CITY OF CODY  
PLANNING, ZONING AND ADJUSTMENT BOARD  
TUESDAY, JUNE 23, 2020  
CITY HALL COUNCIL CHAMBERS @ 12:00 NOON

<b>MEETING DATE:</b>	JUNE 23, 2020	<b>TYPE OF ACTION NEEDED</b>	
<b>AGENDA ITEM:</b>		P&Z BOARD APPROVAL:	X
<b>SUBJECT:</b>	SITE PLAN REVIEW: STORAGE/SHOP BUILDINGS BY MIKE WOOD. SPR 2020-13	RECOMMENDATION TO COUNCIL:	
<b>PREPARED BY:</b>	TODD STOWELL, CITY PLANNER	DISCUSSION ONLY:

**MIKE WOOD STORAGE**

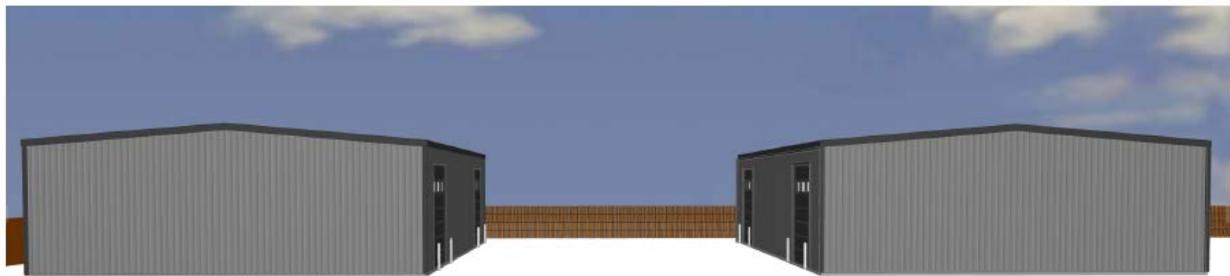
The property is within the downtown architectural district, but the D-2 sign district. The D-2 sign district allows any individual wall sign to be up to 150 square feet in size, and total signage on the property no more than 300 square feet. The individual sign size and total amount of wall signage is well within the allowable amount. The sign otherwise meets the dimensional and locational requirements of the sign code.

The purpose of the Downtown Architectural District is understood to be the promotion of architectural compatibility and preservation of historic features. The proposed sign does not affect the architecture of the building and is of professional quality.

Approve the wall sign as proposed.

PERSPECTIVE VIEW  
N.T.S.

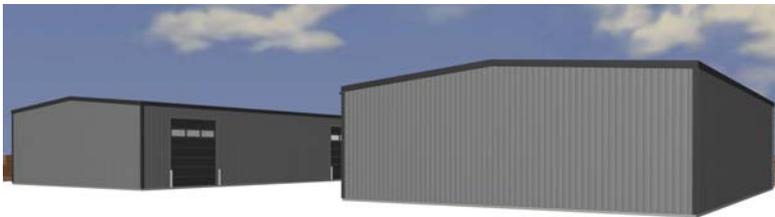
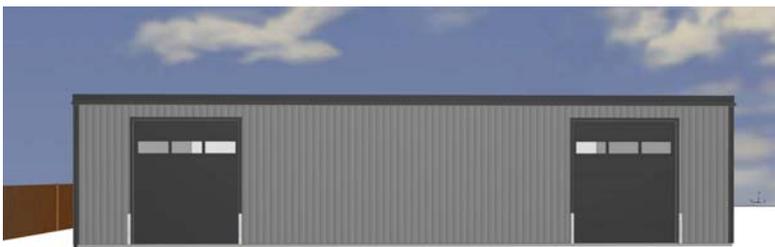
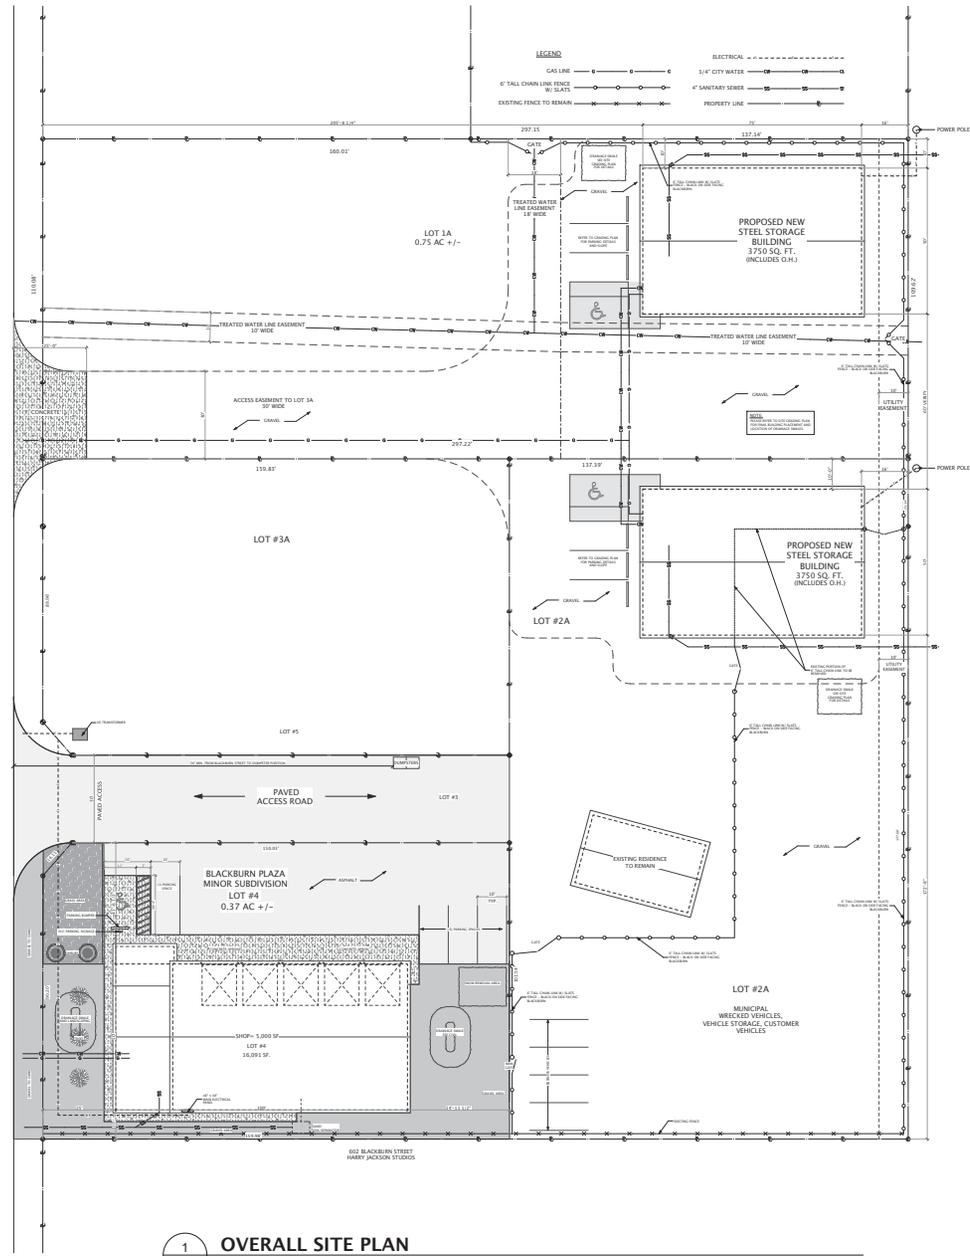
The architectural elevations of the building are attached. The buildings are of typical vertical metal siding and metal roofing. The sidewalls would be 16 feet in height. The roof pitch is 1:12. The wall color is proposed as "ash gray", and all trim is "charcoal gray", which colors match the Eagle Recovery building to the south. The roof would be standard galvalume (galvanized gray). The elevation drawings show no windows or architectural enhancements. However, both buildings are being plumbed for a restroom to allow a shop/office option. As a result, a person door is needed in each building, per building code. It is also possible that windows or front entryways could be added in the future.

Due to the distance of the buildings from the public way, the proposed buildings would not be highly visible. In addition, they actually help screen the vehicle storage on the property from the residences to the north and northeast. Staff is not overly concerned with the lack of architectural features due to these factors, so long as landscaping is used to improve the overall appearance of the site.

OVERALL SITE PLAN

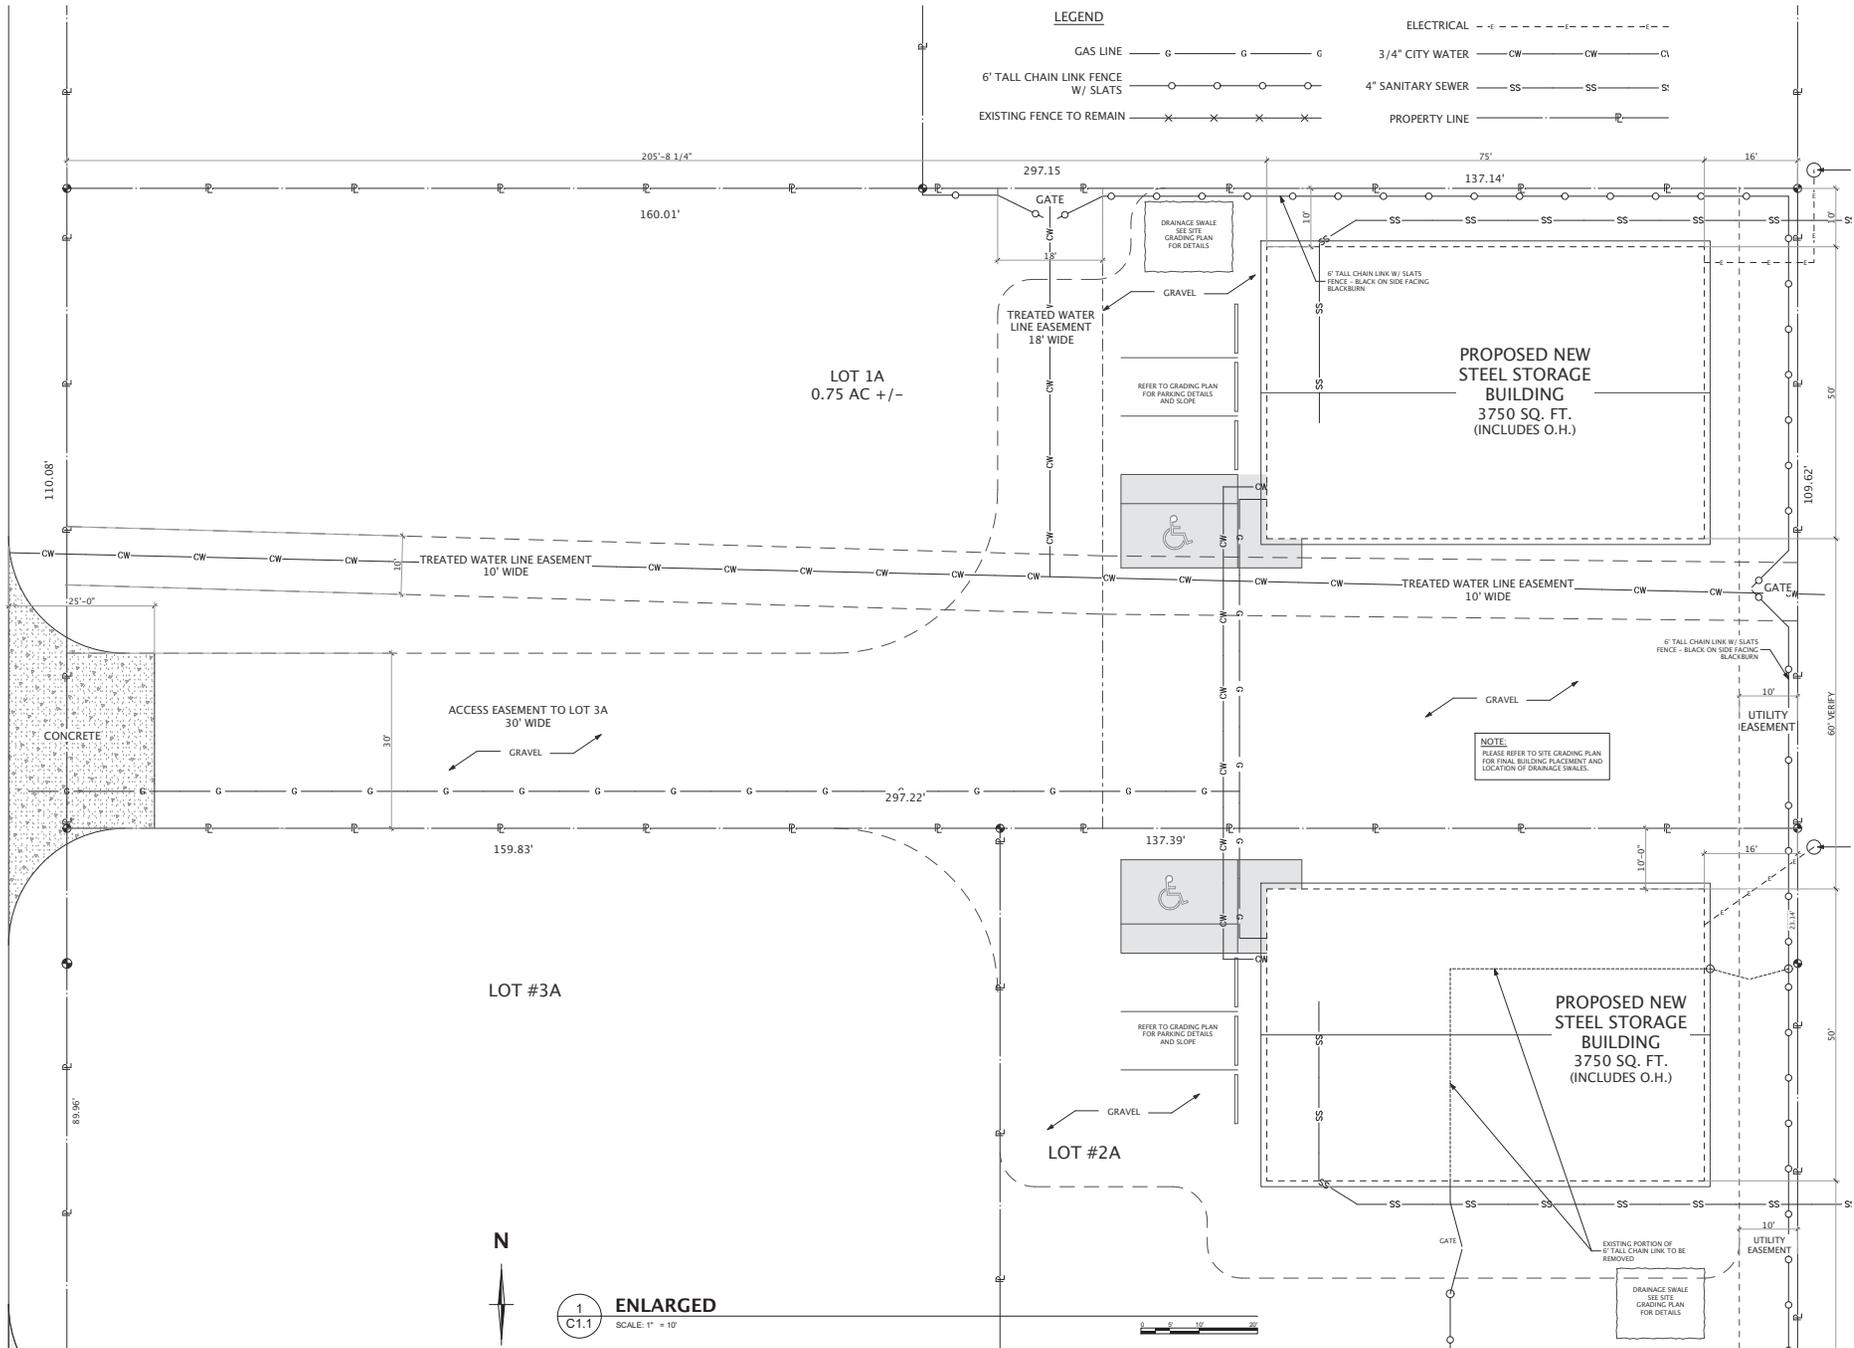
The connection to Blackburn Street is defined by a 30-foot access easement on the underlying subdivision that created the lots. The site plan properly shows that access point being paved (concrete or asphalt) and utilized to serve the proposed development. However, the access easement ends before it reaches the south building.

The options would be to provide an access easement for the south building across the north lot, remove the property line between the lots, or relocate the property line to another suitable location through the lot line adjustment process. Each of those options require a legal document to be prepared and recorded. Without it, there is no legal access to get vehicles in or out of the south building.

The application shows the required gravel surfacing of the access drive and the area for the emergency vehicle turnaround under the fire code (note large turn radii).

The use of the buildings as a shop (occupied area) triggers the requirement for parking. Using the standard of 1.1 spaces per 1,000 square feet for light industrial shops, four parking spaces are required per building. The spaces are shown as required. However, it is noted that the required backup area for the south building extends across an existing property line. Either an easement must be established, or the property line shifted out of the backup area.

The ADA parking spaces are shown as required. They layout of the ADA space and concrete walk is based on the access door being located on the front corner of each building.

The swale shown south of the south building will need to be shifted about 5 feet west from where it is planned, so that the 10-foot City utility easement along the east property line is passable.

No snow storage area is shown. The area north of the north parking area would be ideal, as it would allow the snow to melt into the storm water swale. To the east of the south building would be another suitable area.

The gas company will need an easement for their line. In addition, the plans show the sewer services heading to the east, which would require running the service for the north building on the Richard Noble property and the south service on the Yellowstone Behavioral Health property, to the City sewer main. Easements from the affected property owner(s) must be acquired before those lines can be installed. Alternatively, the sewer could be run to the west, to the main in Blackburn Street.

The site plan also shows electrical services coming from the poles along the east side of the property. That line does not have transformers, and the designated point of service for these lots is from the pad mounted transformer near Blackburn Street (serves existing Eagle Recovery building). The route will need to be modified accordingly. Provide the proposed route to the City electrical engineer for review. Any needed easements for the electrical extension will need to be provided before the line is connected.

2. Verify the planned location of the person door on each building, and ensure that each ADA route extends to each.
3. If the sewer services are to be run to the east, applicable easements must be provided before a plumbing permit is issued for the sewer services. If the sewer services are run to the main in Blackburn Street, provide a utility easement for that route. Cleanouts must be installed per plumbing code. (Note: the 30-foot access easement is not currently designated for utilities.)

4. Any sewer cleanouts or water curb stops that are installed in a driving area are to be protected with concrete collars per City details.
5. Provide plans for extending electrical service to each building from the designated transformer next to Blackburn Street. Coordinate with Bert Pond.

7. Easements must be provided where needed, for any components of the project that cross property lines, including but not limited to utility services, access to the south building, and parking backup/aisle on Lot 3A. (The parking backup/aisle on Lot 3A could be done by parking agreement instead of easement.) Coordinate easement locations and widths with the City. Unless specified otherwise (e.g. #3), the easements must be provided prior to occupancy of the buildings (including any temporary occupancy).

8. Shift the location of the proposed storm water swale south of the south building to be off the City easement.
9. Any applicable city utility fees (water, sewer, electrical) are to be paid prior to building permit issuance—coordinate with Public Works.
